8 February 2023

COMMENTS ON THE DRAFT ENVIRONMENTAL IMPACT ASSESSMENT REPORT FOR THE PROPOSED AFRICA OIL SA CORP BLOCK 3B/4B OFFSHORE EXPLORATION

EIMS REF: 1570

PASA/DMRE REF: 12/3/339

Figure 1: Release points locations, area of interest and sensitivity map, Oil Spill Drift Modeling Technical Report at 8.

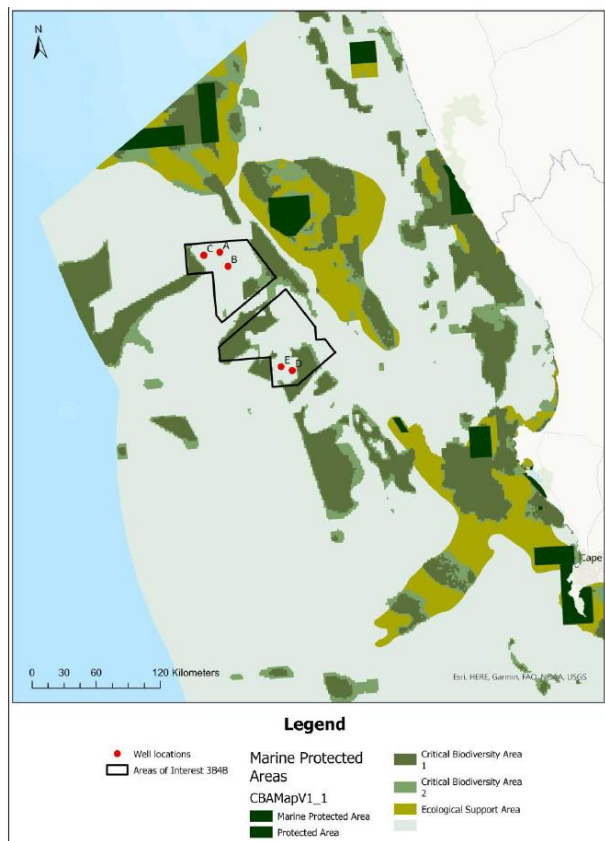
10. The Oil Spill Drift Modeling Technical Report states that "The Release Point selected for the study scenarios represent the worst-case locations in the block" and "Usually a conservative case (worst-case) is chosen, showing for example the shortest time of impact to the coast, or the largest quantity of hydrocarbons to the coast."⁴ The release point used in the model does not meet the criteria for worst case since there are locations inside Block 3B/4B and the designated "areas of interest" that are closer to shore, protected areas, or critical biodiversity areas (see Figure 1 of modeling technical report included below). According to Google Earth, the release point (Point D in the figure) is about ~215 km from shore, while there are locations in the areas of interest that are just ~180 km from shore and other areas in Block 3B/4B that are only ~120 km from shore.

11. Similarly, there are areas of Block 3B/4B and the areas of interest that are much closer to the Childs Bank and Benguela Mud Marine Protected Areas (the dark green patches northeast and southeast of the areas of interest) than the selected release point. The boundary of the areas of interest comes within ~25 km of the Childs Bank MPA, while the block boundary comes much closer to both Childs Bank and Benguela Mud MPAs. Additionally, given the local currents and prevailing wind directions and the technical report's focus on whether spills would impact Namibian or International waters, a location at the northern end of the blocks and areas of interest could reflect more of a worst case scenario.

12. Block 5/6/7 is adjacent to Block 3B/4B and the "ESIA for Exploration Well Drilling in Block 5/6/7 off the South-West Coast of South Africa" published in 2022, modeled two different release points to ensure the worst case scenario was covered.⁵ The Block 3B/4B analysis would better reflect worst case scenarios by similarly modeling two release points, one at the northern edge of the areas of interest (closer to Marine Protected Areas and Namibian waters) and one at the southeastern edge of the areas of interest, closer to shore and nearby MPAs. (See example in Figure 2 below).

Figure 1. The figure below on the right is Figure 1 from the Oil Spill Drift Modeling Technical Report. Well location D was modeled as the release point. Figure 2 on the right shows the same information, with an approximate block outline added in red. The red point marks the release point used in the model. The two blue points illustrate examples of locations that would better illustrate a true worst-case scenario.

Figure 3: Location Map for Block 3B/4B and Africa Oil Assets from Prospective Resources report of independent qualified evaluator for Block 3B/4B, South Africa at 14, https://africaoilcorp.com/site/assets/files/1823/risc_-_africa_oil_corp_prospective_resource_report-_blo.pdf.

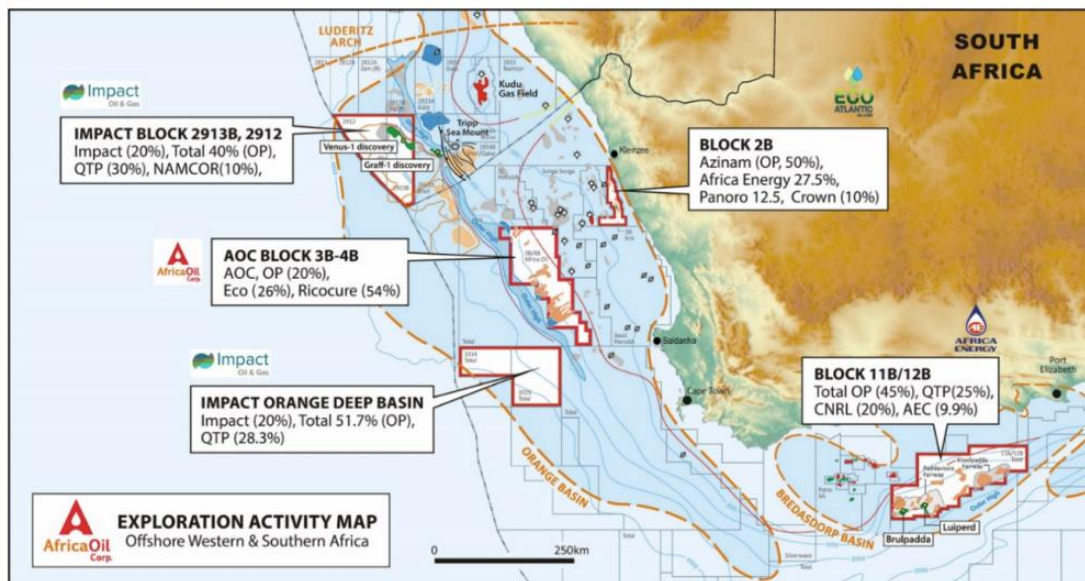
16. The assumption that only gas and condensates would be released during a blowout relied on an assumption that the hydrocarbon profile of Block 3B/4B would be similar to those of the Brulpadda/Luiperd fields. It is not clear why the Brulpadda/Luiperd fields were used as an oil type reference or “analogue reservoir” for spill releases. These fields are located roughly 600-700 km away from Block 3B/4B off the southern tip of South Africa in a different basin, while the Graff-1 and Venus-1 wells in Namibia are located roughly 150-200 km northwest of Block 3B/4B in the same basin (see Figure 2 below). Graff-1 and Venus-1 have yielded light oil while Brulpadda and Luiperd yielded gas condensates.
